City of Richmond

Report to Committee

Re: Application by Oris (Dyke Road) Development Corp. for Rezoning at 6091 and 6111 Dyke Road from Light Industrial (IL) to Commercial Mixed Use – London Landing (Steveston)(ZMU40)

POTENTIAL FUTURE DEVELOPMENT - MASSING IMAGE

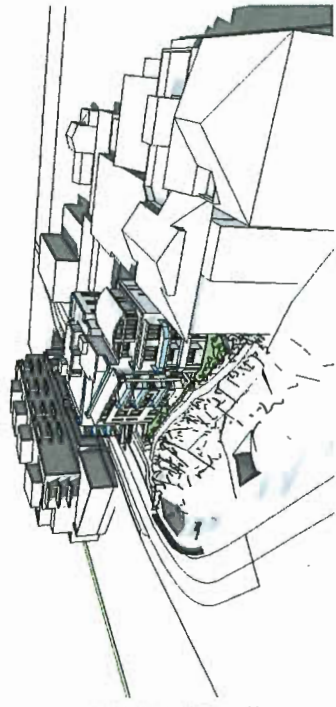
- Concerns about the conceptual development plans for surrounding properties included in this submission for the subject project.
The renderings for the development proposal showing a conceptual massing diagram of the neighbouring areas to the north is to provide context and confirmation that adjacent sites can be redeveloped in accordance with the OCP. Any application on the adjacent sites will be subject to the typical development review process.

Many of the renderings in the drawing package portray the proposed building in the context of "potential development" of the lands to the north and north-east of the subject properties. While I appreciate the developer may have an overall vision for the surrounding properties, I note there is no active rezoning plan for these lands. I do not believe it is appropriate to set a precedent with the proposed building for a theoretical development to the north, as opposed to respecting the existing developed corridor to the east.

- Our renderings are not provided with the intent to mislead anyone, but rather to provide context of the proposed building within the neighbourhood.
 - The Eastern section of the building next to Nakade is the same height as Nakade as shown within the elevations.

ELEVATIONS
WEST & SOUTH

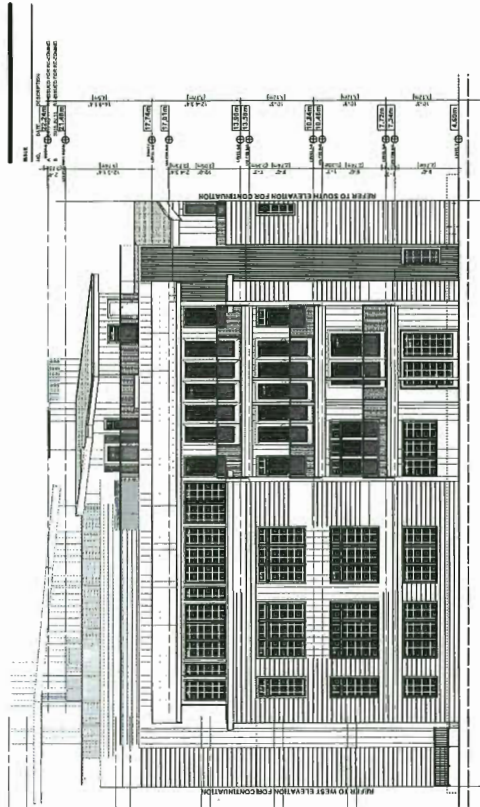
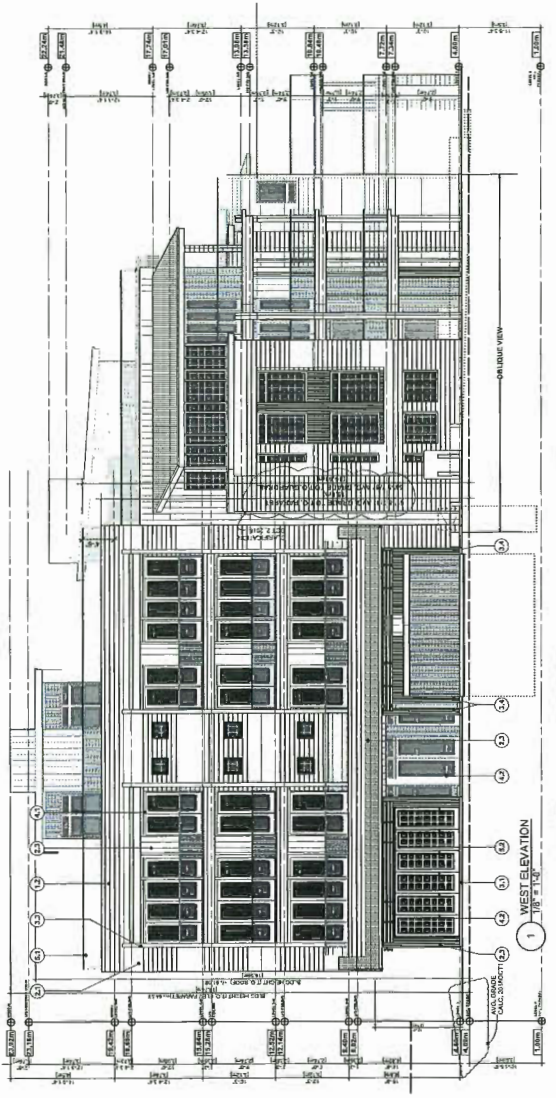
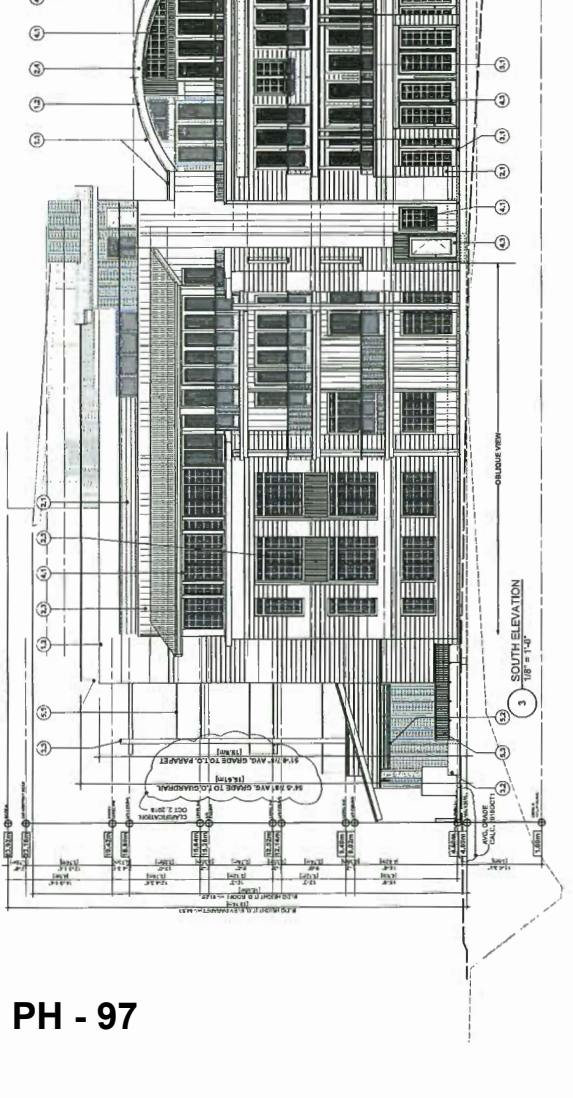
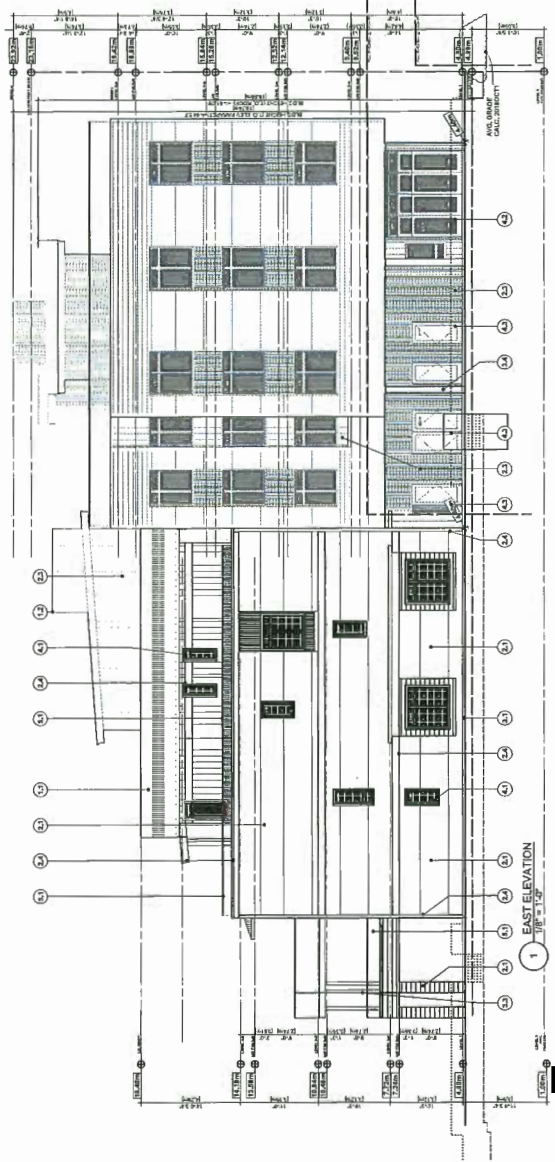
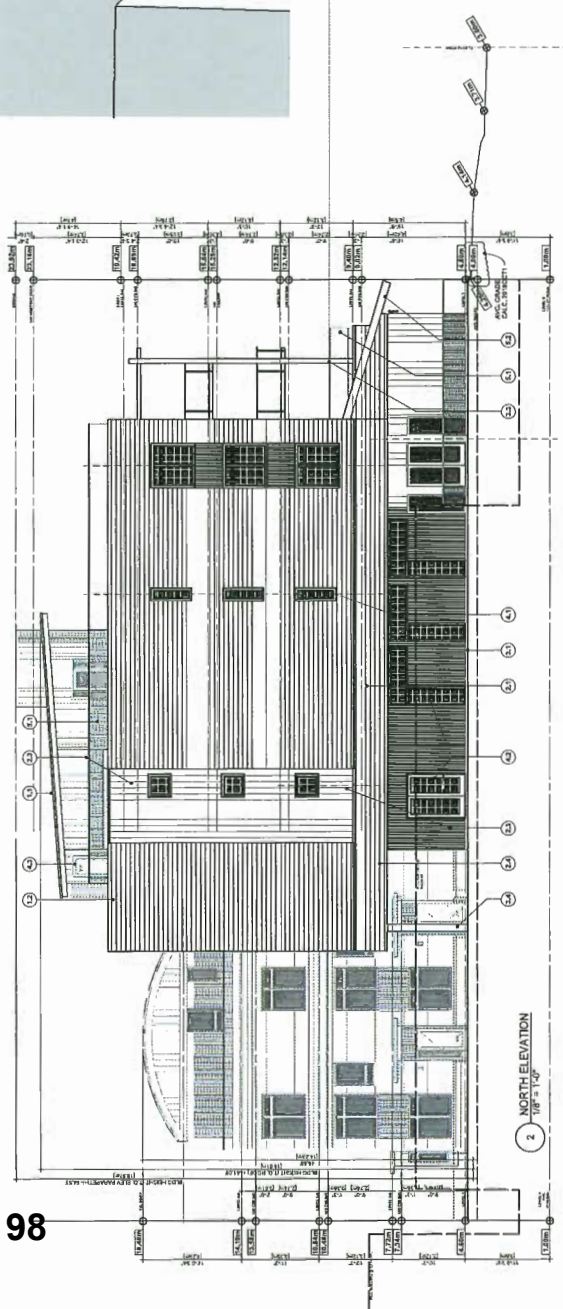
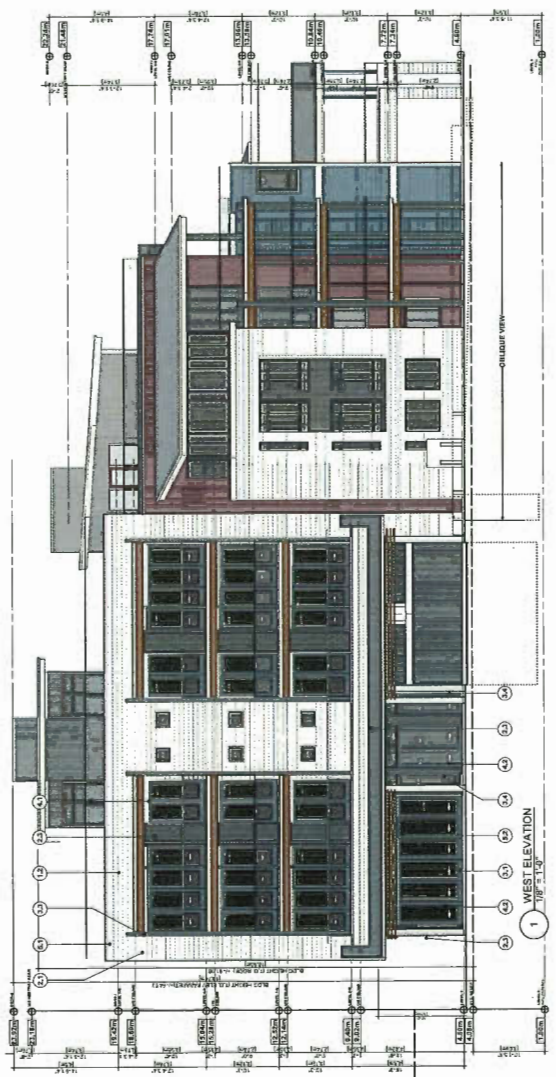
- Comment that the building form and setbacks to Dyke Road (north-south portion) should be similar to the mixed use development on the west side of the street (Kiwaki/The Pier). *Revisions to the project provides for a similar approach to developments to the west with the at grade level 1 setback 1.5 m from the street and a 6 m setback for levels 2-4. The decks that encroach into this setback are designed to have slim profiles with structural glass rails.*

The design and massing of the proposed development should be more aligned to the existing buildings to the east, and the Heritage Precinct that has been so carefully cultivated over time, as a logical continuation and conclusion of the corridor along Dyke Road towards London Farm. As the last developed property along Dyke Rd. facing the river, the proposed development should reflect principles firmly established along that corridor. The current plans do not.

- the north face should be stepped back on the third and fourth levels to provide an appropriate interface to the existing two-storey commercial developments to the north, and to reduce visual blockage to neighborhood buildings to the West, North, Northeast, and East.

- We have made further enhancements to the Southwest facade that looks to respect the heritage character of the developments to the East. We have matched the adjacent parapet heights of Nakade with a simple and contemporary sill/cap detail along with a 4th storey ribbon window design and deck arrangement that tucks under a shed roof form. This area is intended to look like an enclosed deck. This design has been adapted from the key feature of the local McKinney Heritage House next to London Farm. (Context Notes & Point 1 Massing)

- The building increases in height as it moves West to be consistent with the Pier development across the road.
 - We have added massing images from street level to better show this within the architectural drawings.
